# Access Compliance Report

## Public Rights-of-Way

### (Curb Ramps)

Intersection ID: 14193	Main Street: E_5TH_ST	Cross Street: N_CASWELL_RD	Location: E
ADA ID: 284991F6AE64	Ramp Type: PerpDiag	Initial Pass/Fail: Fail	Overall Compliance: No
Severity Score: 25			
Codes/Mitigation Info/Possible Solution		Field Measurements/Component Compliance

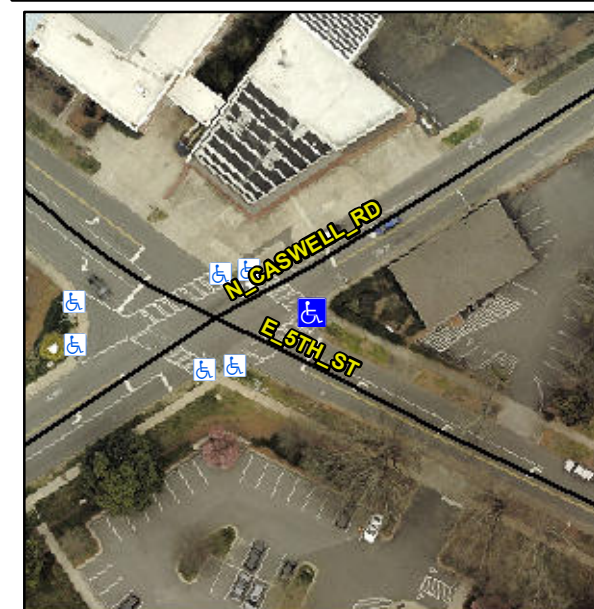
**Not Found, R304.2.2**

Compliance	Description	Data	Compliance	Description	Data
N/A	Ramp Length (in)	48.0	No	Ramp Slope (%)	14.3
Yes	Ramp Width (in)	48.0	Yes	Ramp XSlope (%)	0.3
N/A	Flare Type LT	N/A	N/A	Flare Type RT	N/A
N/A	Flare Slope LT (%)	N/A	N/A	Flare Slope RT (%)	N/A
N/A	Flare Traversable LT?	N/A	N/A	Flare Traversable RT?	N/A
N/A	Landing Length (in)	N/A	N/A	DWS Provided?	N/A
N/A	Landing Width (in)	N/A	N/A	DWS Contrast?	N/A
N/A	Landing Slope (%)	N/A	N/A	DWS Length (in)	N/A
N/A	Landing X Slope (%)	N/A	N/A	DWS Full Width?	N/A
N/A	Landing Curb? (Y/N)	N/A	N/A	DWS Offset (in)	N/A
N/A	Shared Landing?	N/A			
N/A	Gutter Ponding?	N/A	N/A	Gutter Slope (%)	N/A
N/A	Gutter Lip Ht (in)	N/A	N/A	Gutter X Slope (%)	N/A
N/A	Painted X Walk1?	Yes	N/A	Painted X Walk2?	Yes
	X Walk 1 Direction	To NW		X Walk 2 Direction	To SW
N/A	X Walk 1 Width (in)	118.0	N/A	X Walk 2 Width (in)	118.0
	X Walk 1 Slope (%)	3.3		X Walk 2 Slope (%)	5.0
	X Walk 1 X Slope (%)	2.6		X Walk 2 X Slope (%)	2.7

**Remove & Replace Curb Ramp With Two New Directional Ramps or Equivalent.**
